THE PORT OF CORPUS CHRISTI'S
PROPOSED DESALINATION FACILITY

**Attachments Supporting the Presentation to EPA by the Port Aransas Conservancy¹
On the Port of Corpus Christi Authority's Discharge Permit for its
Proposed Harbor Island Desalination Facility**

**For Meeting with EPA
December 8, 2021**

The Location of the Proposed Desalination Plant

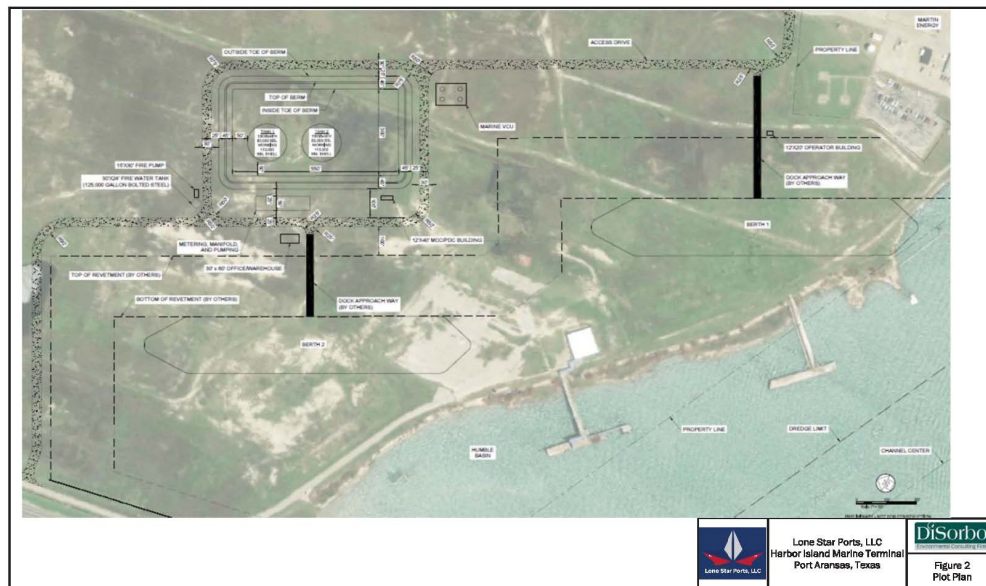
The TCEQ approved the marine terminal facility this year using the map above. Yet now it is reviewing the desalination facility permit for the exact same location. The two facilities are mutually exclusive as currently mapped, with the proposed desalination facilities overlapping with proposed terminal facilities in a manner that is not feasible for both to co-exist. These are just a few examples of the routinely contradictory information the Port presents to permitting agencies.

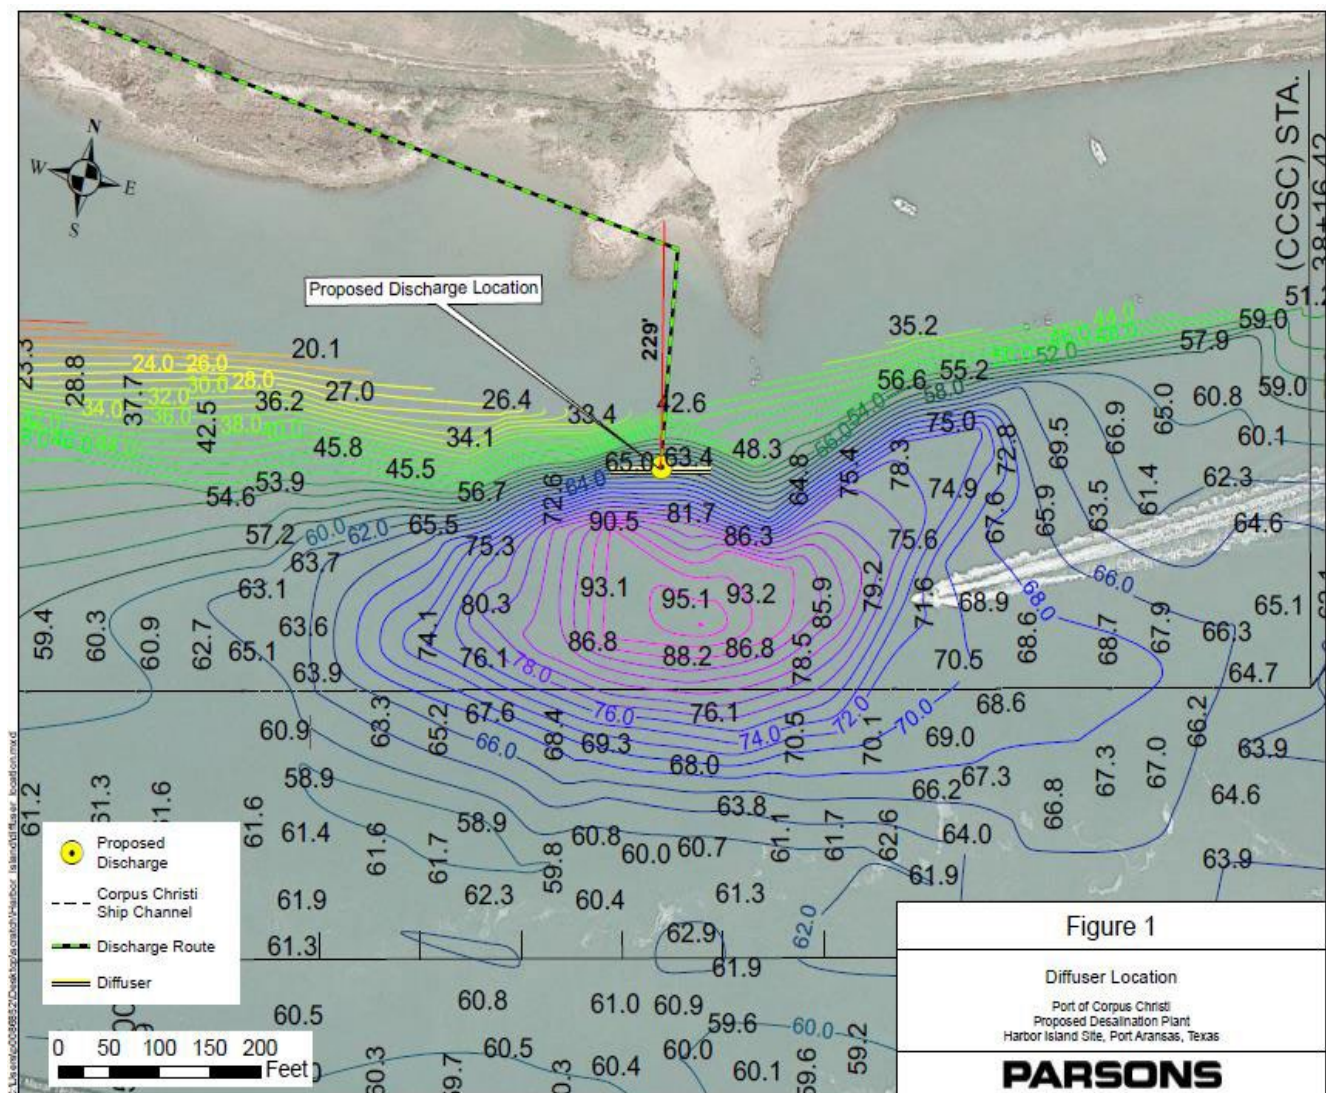
- The jets for the diffuser discharge are proposed at an elevation of about 64 feet below mean low tide in a 95 foot hole in the Corpus Christi Ship Channel, a channel currently authorized for dredging to a depth of only 54 feet.

- The location of the diffuser, which is on the side of the 95 foot hole, is also proposed to be in a small cove, which will result in the hyper saline effluent plume running into the sides of the cove to the east and west well before it reach any boundary of the three mixing zones during most tidal conditions.

- The dense saline plume will then turn toward the center of the channel and sink into the 95 foot hole. It will not jump over the hole.
- The plume will be aided in its movement around and into the hole by the eddy that the Port claimed was well known and created the hole and which the Port now claims does not exist.

- The plume is also aided in its rotational movement by the flow in the ship channel close to the side of the hole, at and below 64 foot depth, especially as the channel waters flow around the two points of land that extend out into the channel above and below the water.

- Once the dense saline plume is in the hole it will remain there, given the constant addition of new hyper saline effluent. There is no evidence, study or basis for the Port's position that the dense plume will be washed out by tidal action.

The yellow line represents the alignment a length of the line of ports for the diffuser which is also aligned along the north boundary of all three mixing zones.
